## **EXHIBIT 2**

**General Electric Aviation**  
**on Draft NPDES Permit No. MA0003905**  
**for Discharges from GE's Facility at**  
**1000 Western Avenue, Lynn, Massachusetts**

**June 1, 2011**

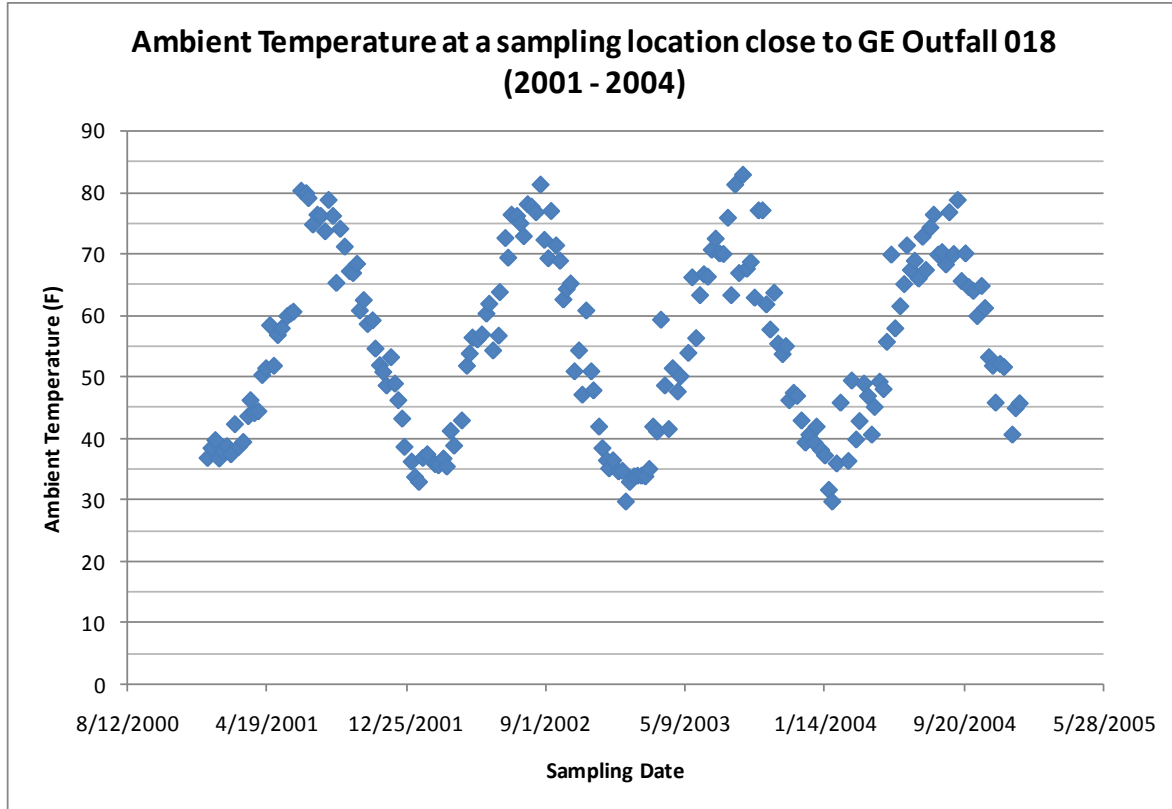
As demonstrated by the plan-view and cross-sectional figures of the modeled thermal plume in Technical Exhibit 18 to these comments, the Power Plant thermal plume projects away from the shoreline out into the deeper main channel of the river (Technical Exhibit 18, Figure 2.7). The lateral distance of the plume from Outfall 018 (following its trajectory as shown in Technical Exhibit 18, Figure 2.7) and its depth below the surface during low-water slack tide (Technical Exhibit 18, Figure 2-3) show that (1) the plume does not extend across the river to the shallow-water and saltmarsh habitats near the southern shore of the river, and (2) a substantial zone of the river (in terms of both width and depth) is unaffected by the 2°F isotherm. Thus, even at low-water slack tide, a substantial zone of passage remains in the Saugus River in the vicinity of Outfall 018 for juvenile fish to avoid rapid exposure to and swim away from the relatively gradual change in temperature associated with the thermal plume. Moreover, these conditions represent the maximum extent of the plume under low-water slack tide. That condition persists for less than 30 minutes, further limiting the exposure of young fish to elevated temperatures.

Although EPA suggests that GE's 1993 modeling may not accurately reflect the temperature profile of the Facility's plume, there are good reasons to believe that the model provides a reasonably accurate representation of its dimensions. See "Thermal/Biological Impact Analysis – Outfall 014 General Electric River Works Facility" (ENSR, 1993b). The effluent temperature of 95°F was used as a model input for discharges for the Test Cell at Outfall 014. Based on the modeling results, the predicted thermal plume from Outfall 014 exceeding 84.4°F is about 20.5% of the total cross sectional area and 10% of the total surface area encompassed by temperature isotherms (when effluent temperature is 95°F). See "Thermal/Biological Impact Analysis – Outfall 014 General Electric River Works Facility" (ENSR, 1993), pp. 4-15 and 4-16. By way of analogy and extrapolation, it could reasonably be expected that Outfall 018 would observe a similar percentage increase when the effluent temperature is 95°F. It is important to note that 20.5% of total cross sectional area and 10% of the total surface area encompassed by temperature isotherms are still relatively small areas. Therefore, the incremental impact of the thermal plume on the BIP of fish in the Saugus River also would be relatively small.

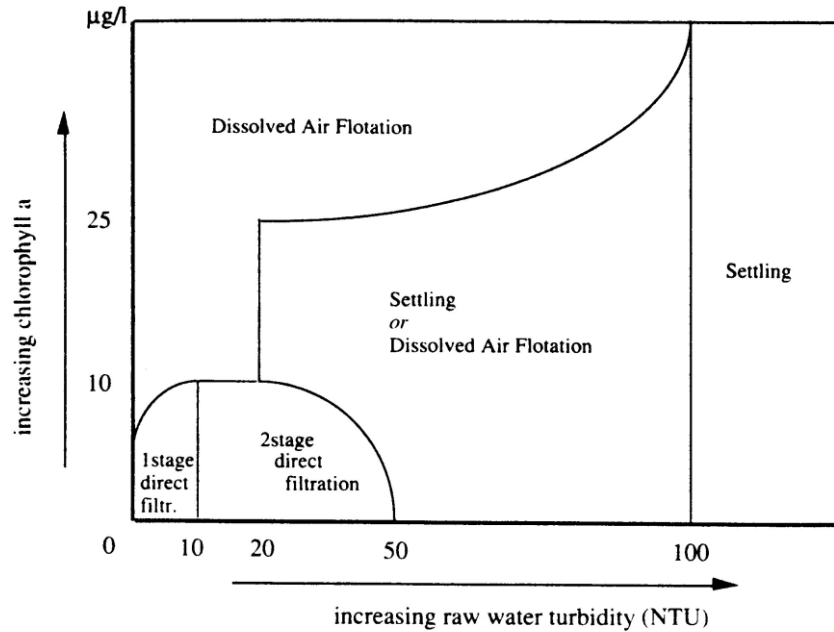
EPA assumes that "pollutant discharges would be reduced the most by operating the CDTS in the mode utilizing both DAF and GAC treatment." Fact Sheet p. 8. However, this assumption is not correct. To fully understand this issue, it is critical to first address the original design philosophy of the CDTS, and to compare this design philosophy to GE's actual operating experience over the last ten years.

The design and installation of the CDTS was an element of GE's comprehensive sheen reduction program. During the design process, GE's understanding of the sheen issue was evolving. As a result, the CDTS design philosophy accommodated a wide range of influent characteristics and provided the operating flexibility necessary to achieve the discharge performance standards. In this regard, a key unknown was the amount of free product or floating oil and grease that would be present in the wastewater pumped from the respective drainage system vaults to the CDTS. To address this unknown, dissolved air flotation (DAF) technology was selected as an element of the treatment system to provide the capability for the removal of free product and floating oil and grease should these pollutants exist in sufficient quantity.

Other technologies (i.e., unit processes) utilized in the CDTS include influent equalization and skimming, and granular activated carbon (GAC) polishing. In addition, the system incorporated the existing skimmers and oil water separators associated with each respective drainage system vault. The system design was reviewed and approved by EPA and MADEP in the context that
